**TOWN OF SOUTHEAST
PLANNING BOARD/ARCHITECTURAL REVIEW BOARD AGENDA**

March 23, 2026

To: Town of Southeast Planning Board
From: AKRF, Inc.
Date: March 17, 2026
Re: Rraci's Starr Ridge Road
cc: John M. Watson, PE

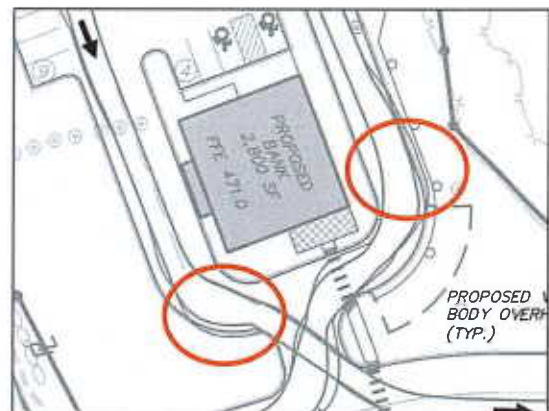
3/17/26: Comment not addressed. The below excerpts from sheet VM-1 indicate potential conflict with the proposed Route 6 driveway pork chop island and curbing for the drive-thru driveway. The curbing should be modified to accommodate fire truck movement. In addition, the Applicant should confirm whether the roadway grades (in excess of 10%) have been reviewed by the fire department.

Figure T-1 – Turning Moving Analysis, prepared 3/17/26.

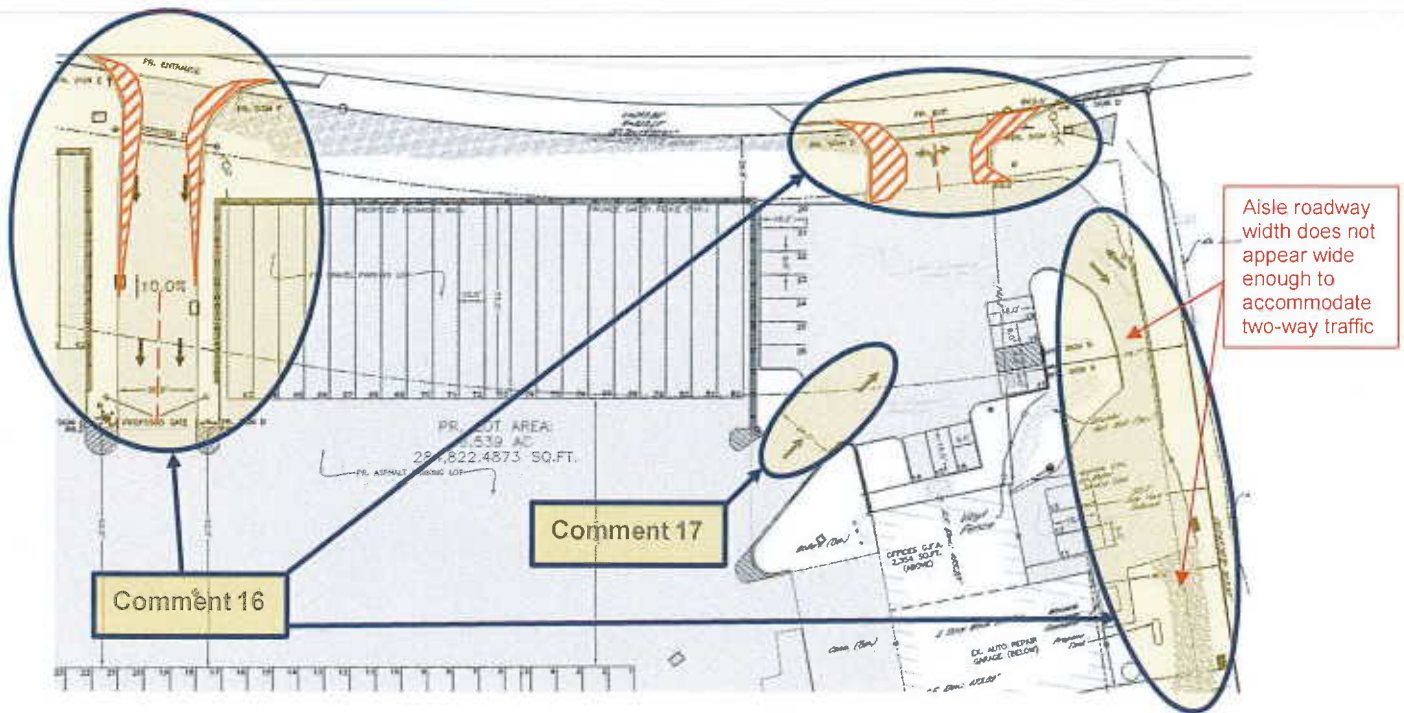
space for tractor trailers to perform required turning maneuvers safely. In addition, the aisle along the northern perimeter of the site has pavement markings designating two-way traffic flow; however, there are sections of this aisle (both paved and gravel) that do not appear to be wide enough to accommodate two-way traffic. See Figure T-1, below (following Comment #17).

3/17/26: Comment partially addressed. The site plan (Sheet 2) shows the location of signage and pavement marking, and sign details are provided on Sheet 8. (Note, Sheet 8 labels two signs as “Sign A.” It appears that the “No Parking Anytime” sign is incorrectly labeled as “Sign A” and should be “Sign B”. This should be corrected.) The traffic flow directional arrow pavement markings in the vicinity of parking spaces 14 through 26 designate one-way northbound traffic flow on Sheet 2 (“Layout Plan”) of the site plan set, but the truck turning path drawings (TT-01 through TT-04) show traffic flow directional arrow pavement markings that designate two-way traffic flow in the same area. The traffic flow directional arrow pavement markings should be consistent across all drawings throughout the site. See Figure T-1, below.
